Access Compliance Report

Public Rights-of-Way

(Curb Ramps)

Intersection ID: 10012737	Main Street: WARP_ST	Cross Street: N/A	Location:	N
ADA ID: 4D0CD200AE39	Ramp Type: Perp	Initial Pass/Fail: Fail	Overall Compliance: No	Severity Score: 8.75
Codes/Mitigation Info/Possible Solution		Field Measurements/Component Compliance

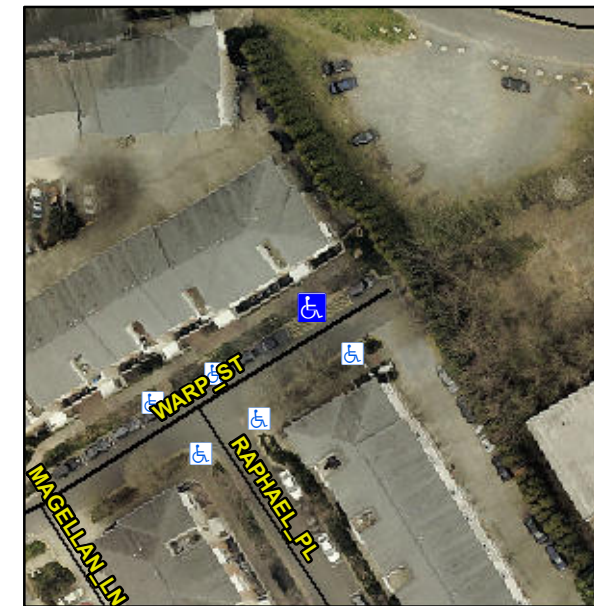
Not Found, R304.5.1

Compliance	Description	Data	Compliance	Description	Data
N/A	Ramp Length (in)	96.0	Yes	Ramp Slope (%)	7.6
No	Ramp Width (in)	47.0	Yes	Ramp XSlope (%)	1.4
N/A	Flare Type LT	N/A	N/A	Flare Type RT	N/A
N/A	Flare Slope LT (%)	N/A	N/A	Flare Slope RT (%)	N/A
N/A	Flare Traversable LT?	N/A	N/A	Flare Traversable RT?	N/A
N/A	Landing Length (in)	N/A	N/A	DWS Provided?	N/A
N/A	Landing Width (in)	N/A	N/A	DWS Contrast?	N/A
N/A	Landing Slope (%)	N/A	N/A	DWS Length (in)	N/A
N/A	Landing X Slope (%)	N/A	N/A	DWS Full Width?	N/A
N/A	Landing Curb? (Y/N)	N/A	N/A	DWS Offset (in)	N/A
N/A	Shared Landing?	N/A			
N/A	Gutter Ponding?	N/A	N/A	Gutter Slope (%)	N/A
N/A	Gutter Lip Ht (in)	N/A	N/A	Gutter X Slope (%)	N/A
N/A	Painted X Walk1?	No	N/A	Painted X Walk2?	N/A
	X Walk 1 Direction	To SE		X Walk 2 Direction	N/A
N/A	X Walk 1 Width (in)	N/A	N/A	X Walk 2 Width (in)	N/A
	X Walk 1 Slope (%)	1.5		X Walk 2 Slope (%)	N/A
	X Walk 1 X Slope (%)	1.3		X Walk 2 X Slope (%)	N/A

Remove & Replace Entire Ramp.
